Company	Trenz Electronic GmbH
PCN Number	PCN-20261126
Title	TEI0050-01 SDRAM Change
Subject	BOM Change
Issue Date	2026-11-26

This change affects all Trenz Electronic TEI0050 SoMs: TEI0050-01*.

Locate SDRAM (U2) on the top side of TEI0050-01 PCB:

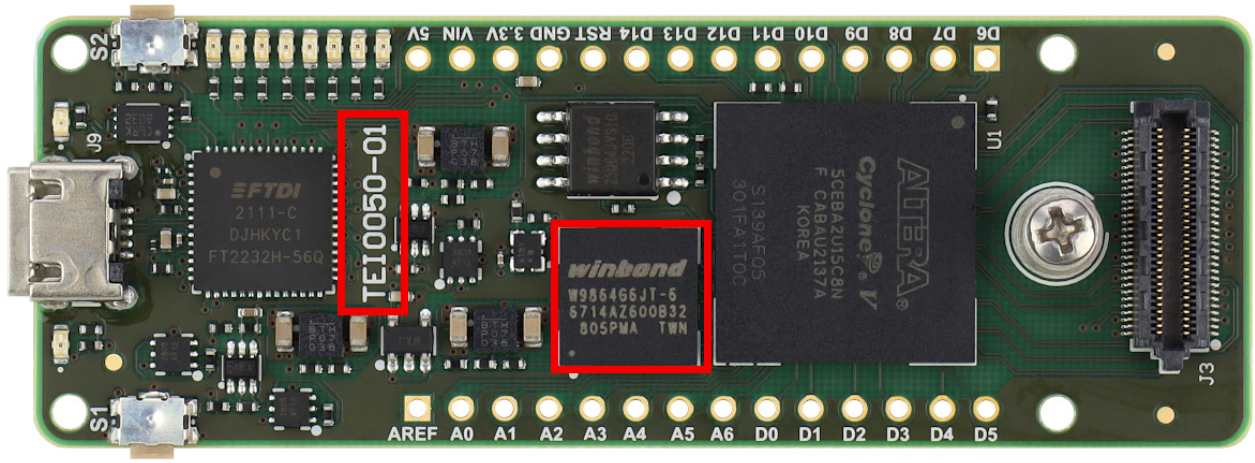
#1 Changed SDRAM (U2) from W9864G6JT-6 to W9864G6KT-6.

Impact: None. New DDR timings may be considered in designs. SDRAM setup used in Trenz reference designs is known to work still.

Old	New
W9864G6JT-6	W9864G6KT-6
